DRAWINGS

DATE: April 3, 2025

WEST END WATER FACILITY W.O. 19-12

Reservoir Fill Material Delivery

CIVIL
OVERALL SITE PLAN
 SHEET NAME: 00C001.dwg
 SHEET NUMBER: **00C001**

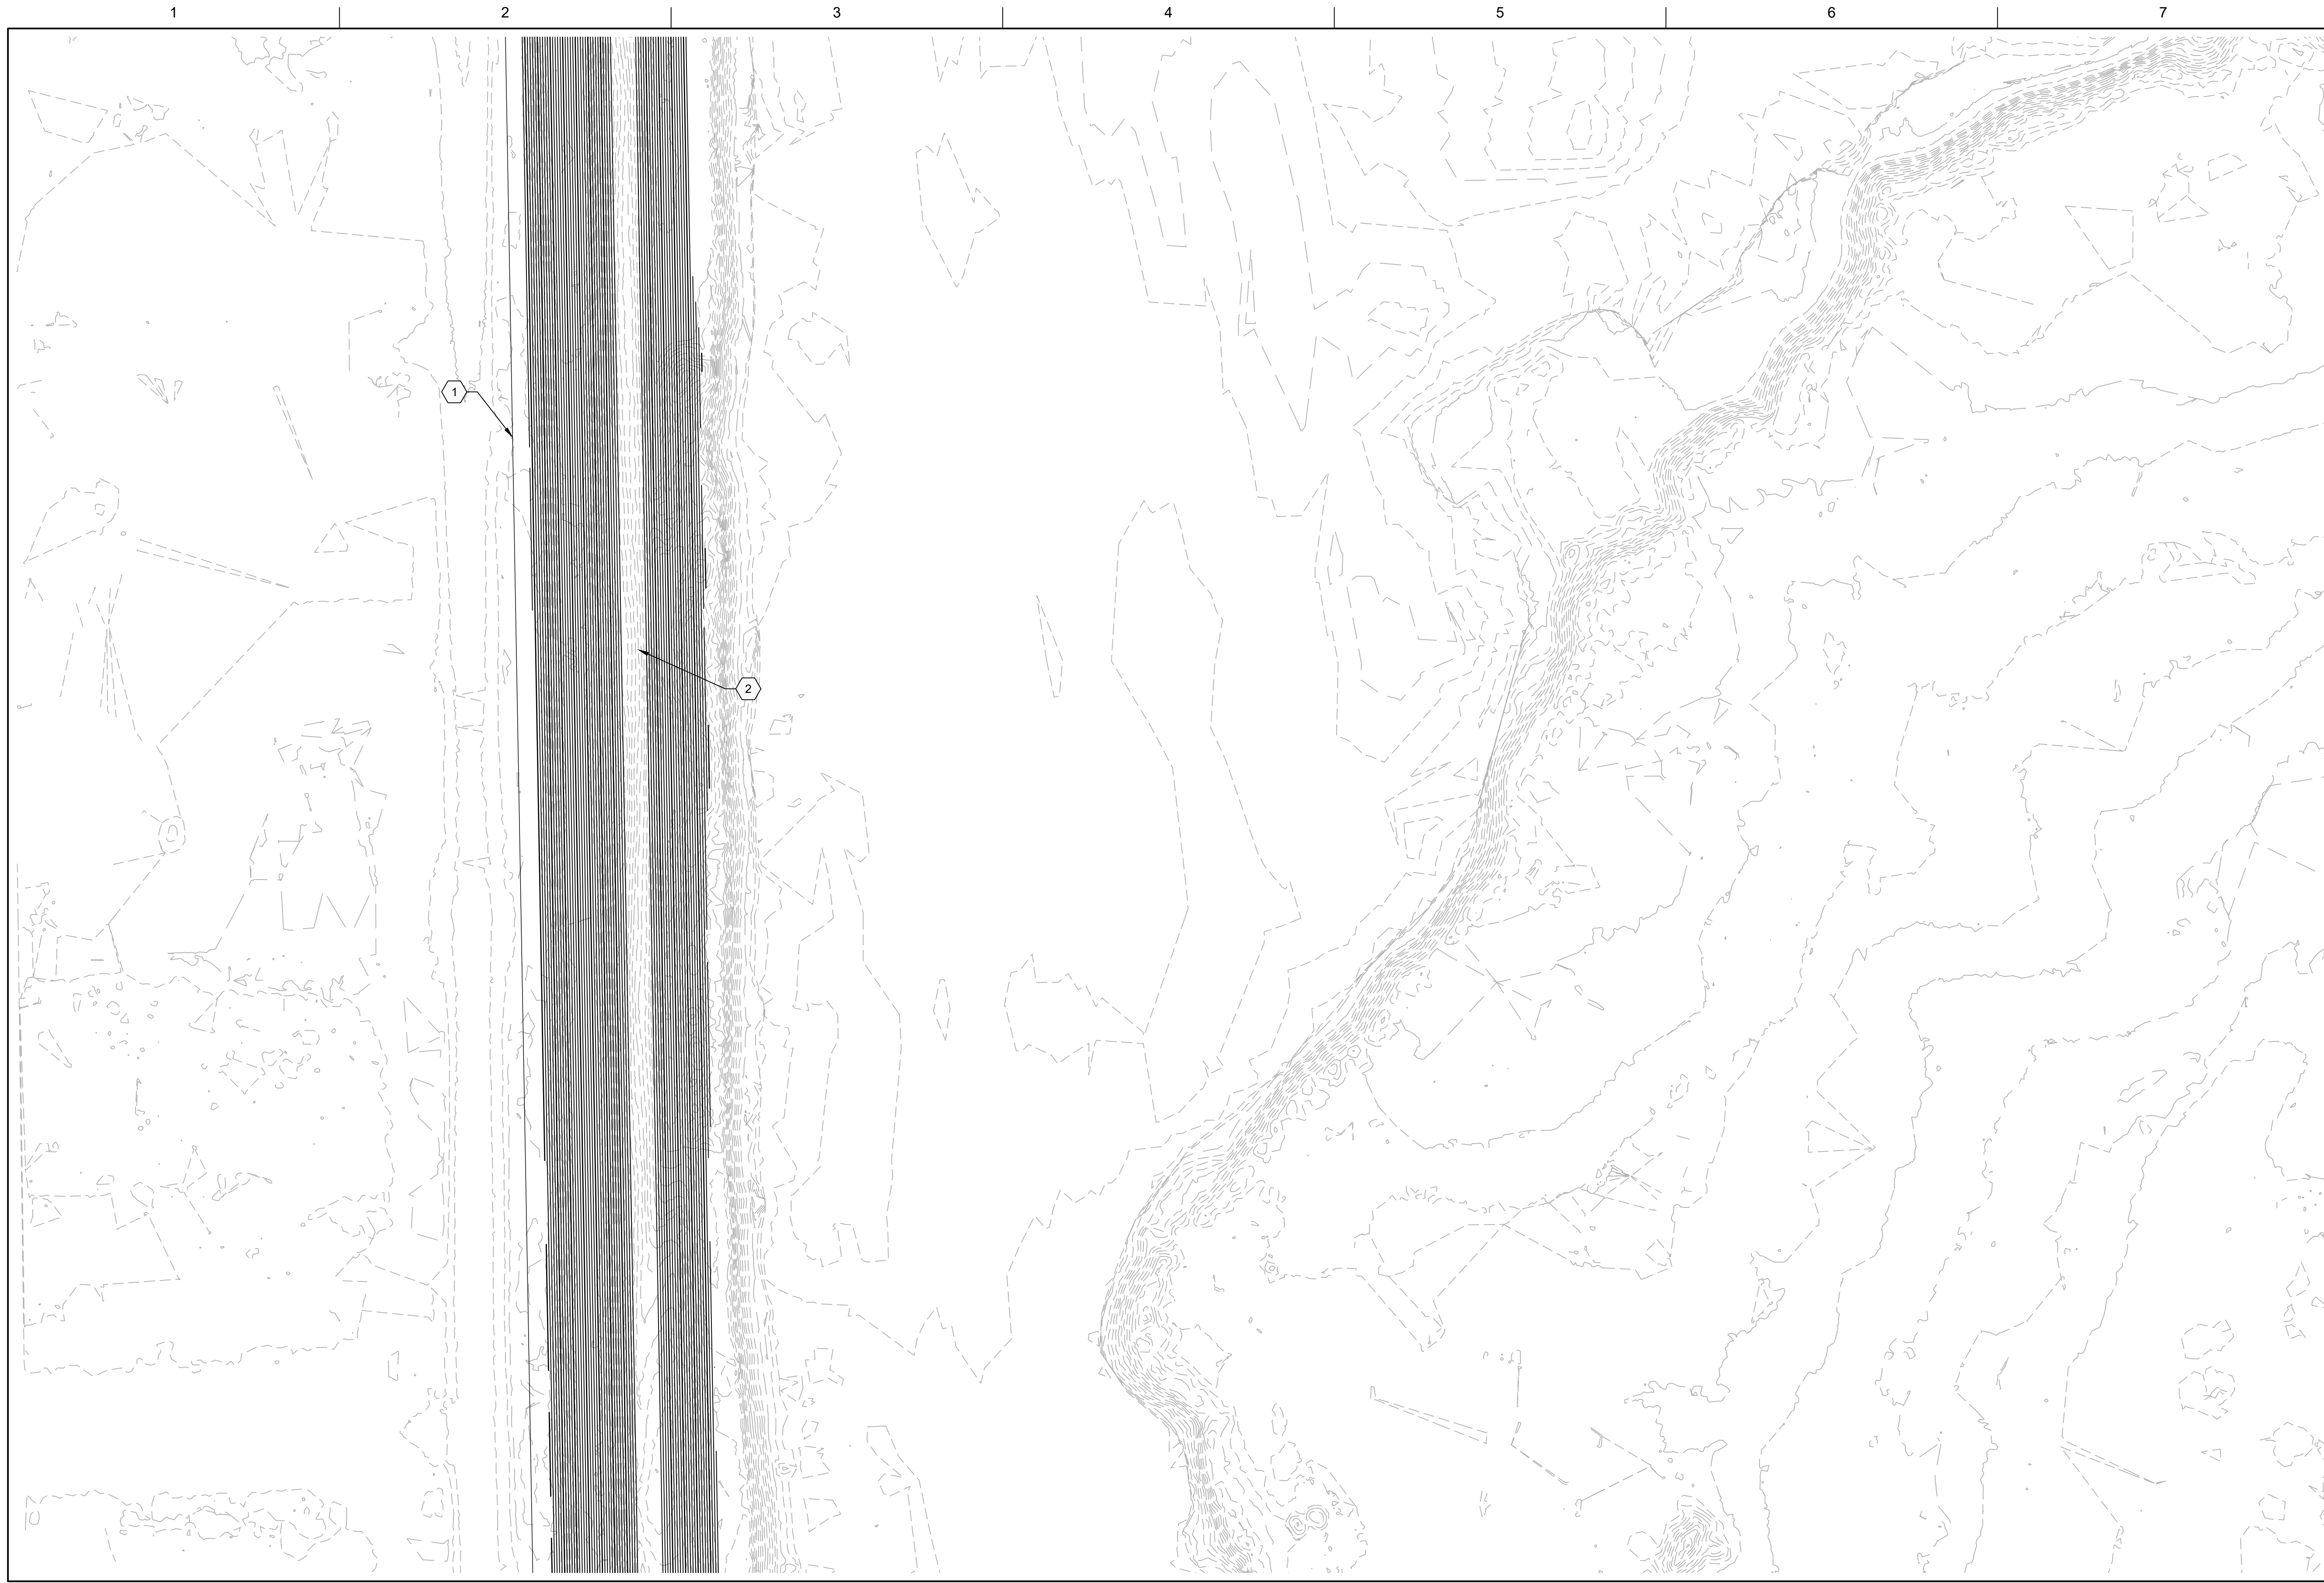
AD-1 Item 4. Sheet 00C001. Drawing Reference Area D5. DELETE “EXCAVATION AREA” and REPLACE with “STOCKPILE AREA FOR MATERIALS FROM CLEARING AND GRUBBING”

AD-1 Item 5. Sheet 00C001, 00C002, 00C003, 00C004 and 00C005. General Note 1. ADD the following to the end of the note:

AD-1 Item 6. Sheet 00C001, 00C002, 00C003, 00C004 and 00C005. General Note 5. INSERT the words “AND GRUBBED” after the word “CLEARED” in the two places it occurs.

“AREAS THAT ARE GRUBBED AND NOT IN THE PRIMARY CUT AREAS WILL NOT REQUIRE AN ADDITIONAL 6 INCHES OF CUT.”
